No. 2031, Rev. II
ATA Code 25-00

EQUIPMENT/FURNISHINGS - NOTICE OF AVAILABILITY OF SHOULDER HARNESS KITS

Issued: June, 1985

Revised: September, 1990

Cabin Door Latch Points
Figure 1

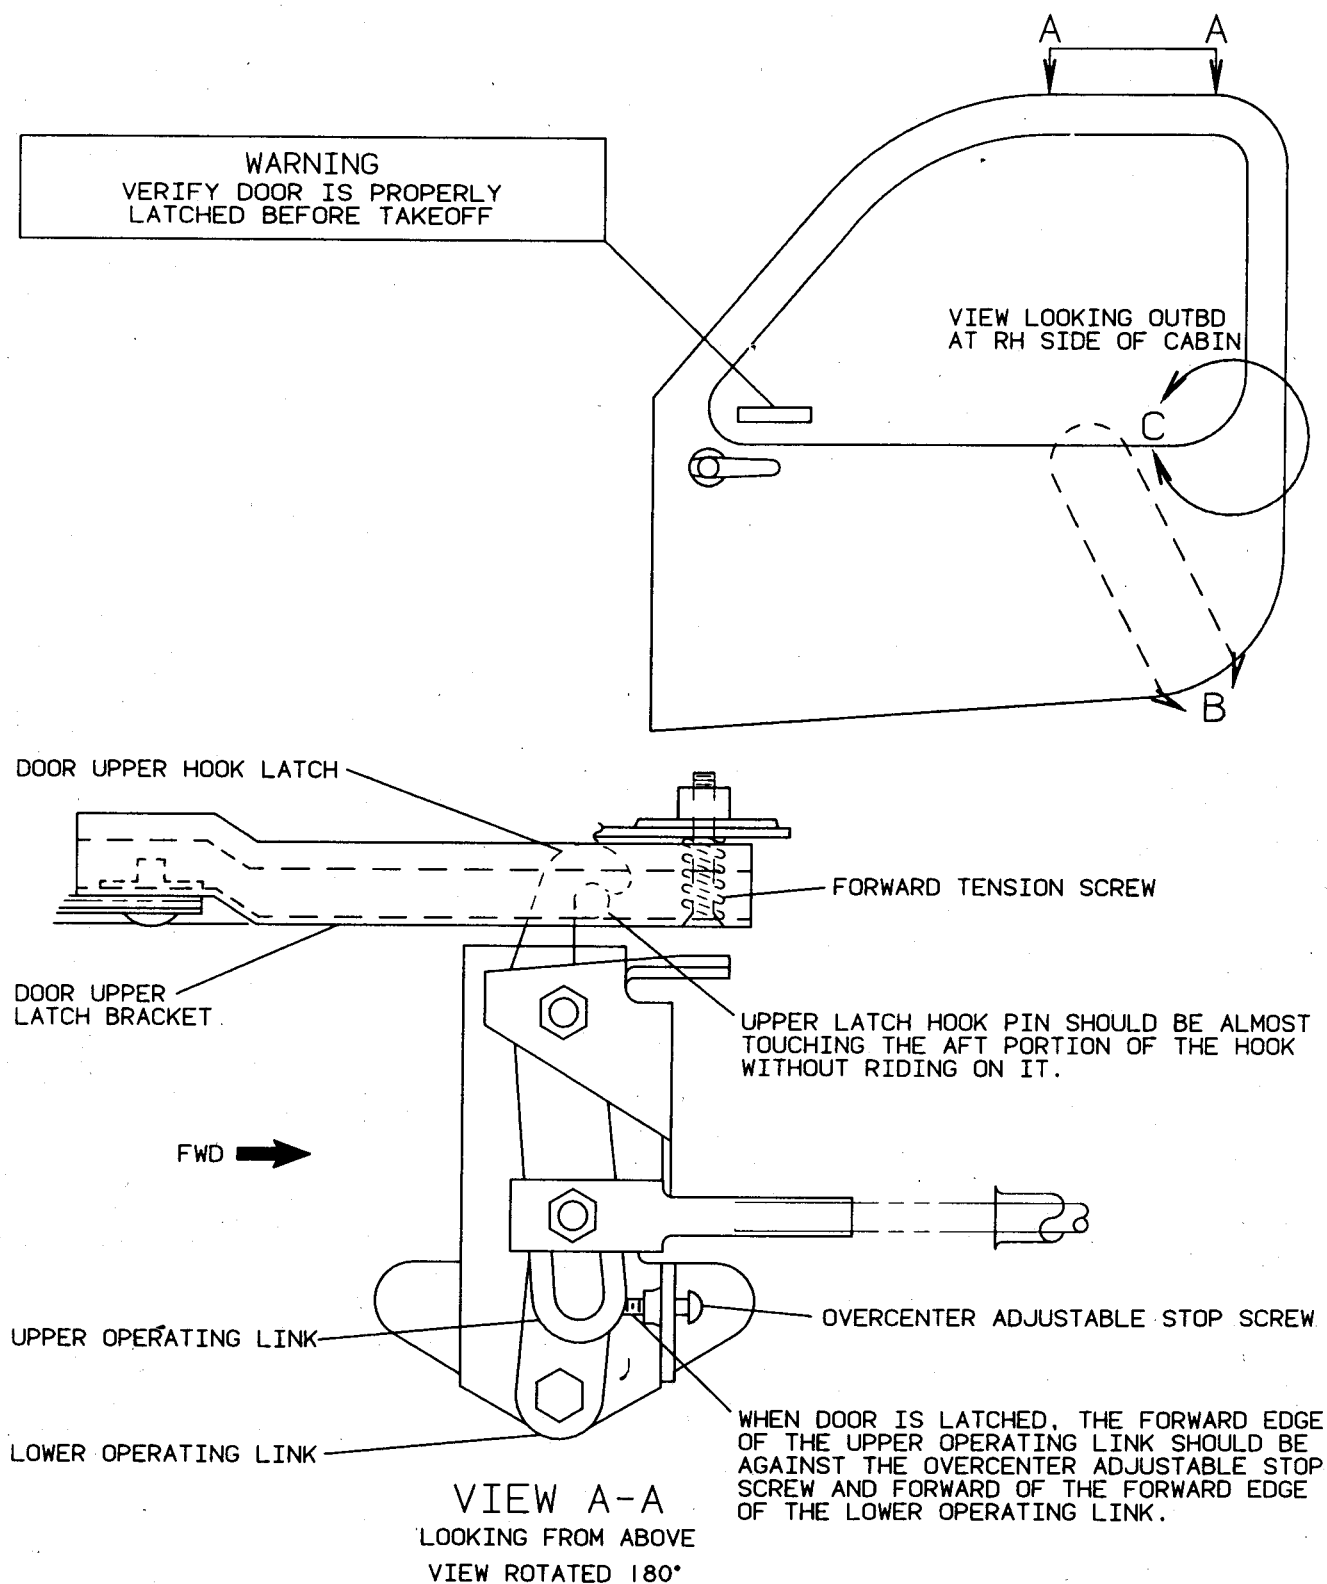
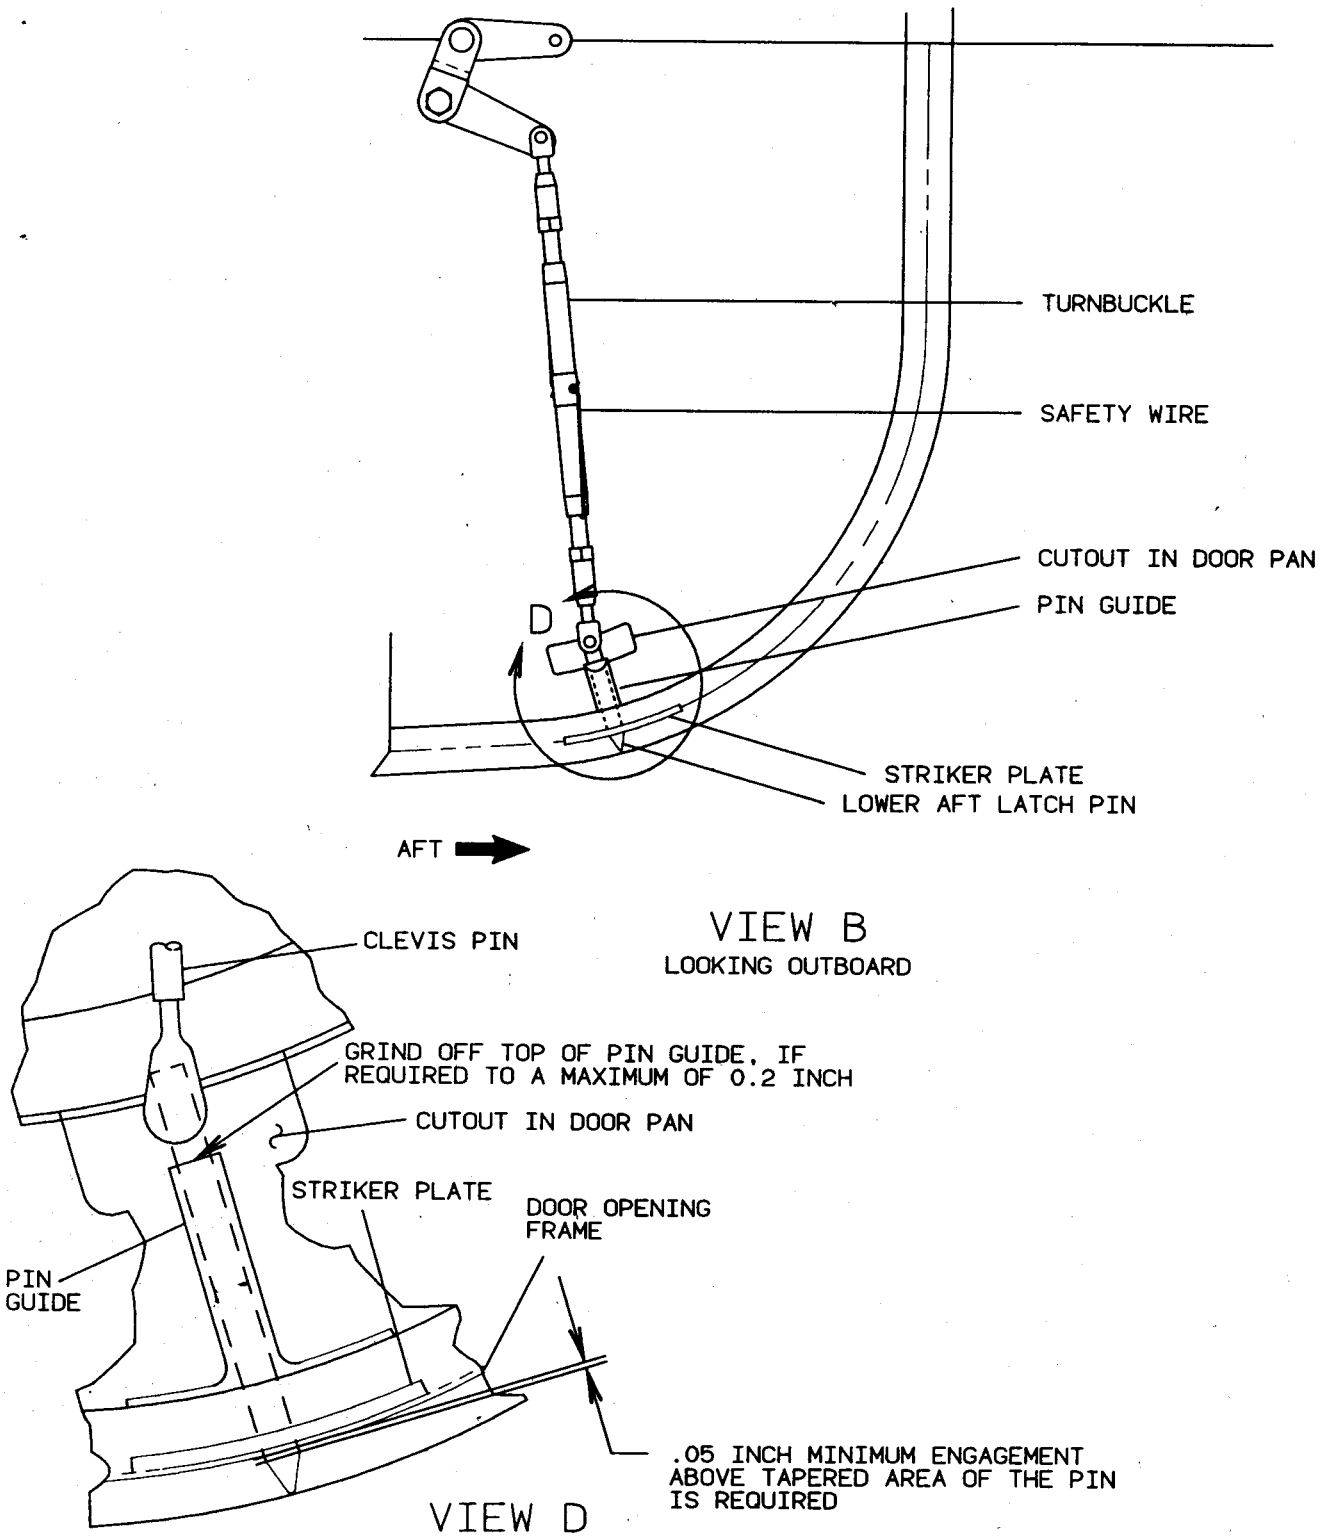
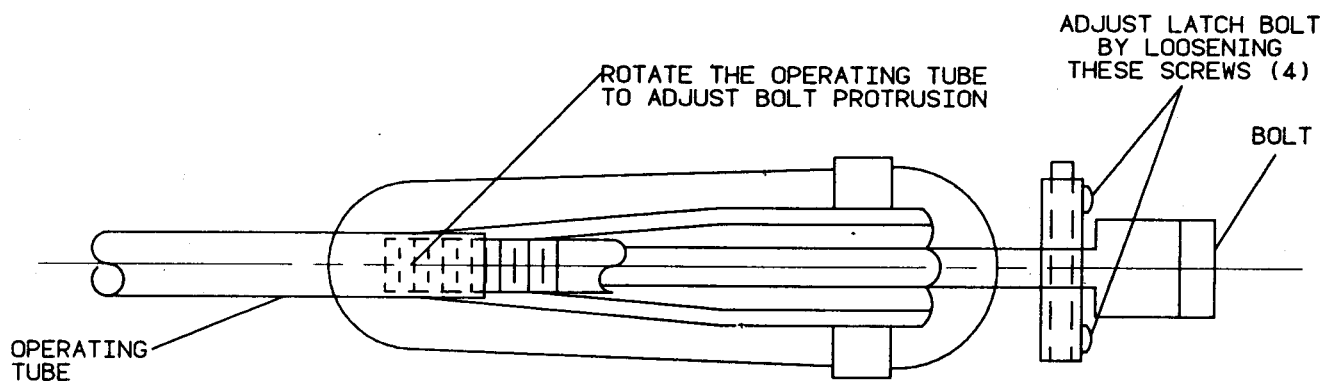
1) Referring to Figure 1, View A-A, check to ensure that the upper latch mechanism is over center when the door is latched. This can be accomplished by using a small inspection mirror to see that the upper operating link is against the adjustment screw and the forward edge of the upper operating link is forward of the forward edge of the lower operating link. If the latch mechanism is not over center when the door is latched, adjust the overcenter stop screw.

2) Referring to Figure 1, View A-A, check to ensure that the upper latch hook pin is positioned so that it is almost touching the aft portion of the hook, but not riding on the hook. If the upper hook does not properly engage the pin, move the pin forward or aft (it has four positions) to obtain proper adjustment.

between the door and the frame, the upper latch bracket needs to be adjusted "in" to create more tension on the door. This can be accomplished by adjusting the forward tension screw. Refer to Figure 1, View A-A.

c. **AFT LATCH BOLT** - Check to ensure that the aft latch bolt provides a precatch and protrudes into the socket on the aft door frame as far as possible without bottoming out. If adjustment is required, proceed as follows, referring to Figure 1, View C.

- 1) Disconnect the operating tube at the inside door handle.
- 2) Disconnect the lower aft latch pin mechanism from the operating tube (if applicable).
- 3) Rotate the tube to allow the bolt to protrude the proper distance.

- 4) Reconnect the lower aft latch pin mechanism (if applicable) to the operating tube. Reconnect the operating tube to the inside door handle.

View Looking Inboard From RH side of Door
Figure 1

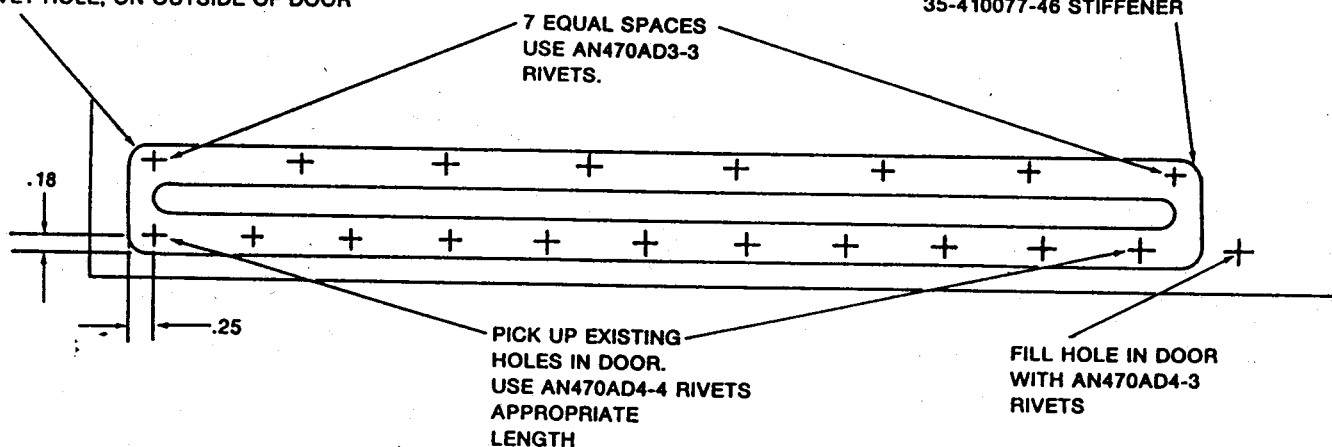
This Service Bulletin replaces the P/N 95-410031-23 stiffener angle. The stiffener is located at the aft end of the R. H. nose landing gear door, at the lower edge (with the doors open) on the inboard side of the door. The new stiffener, P/N 35-410077-46 will be put on the outboard side of the door.

1. Remove the P/N 95-410031-23 stiffener angle *NO PRECIO* on the aft, inboard side of the RH nose landing gear door.
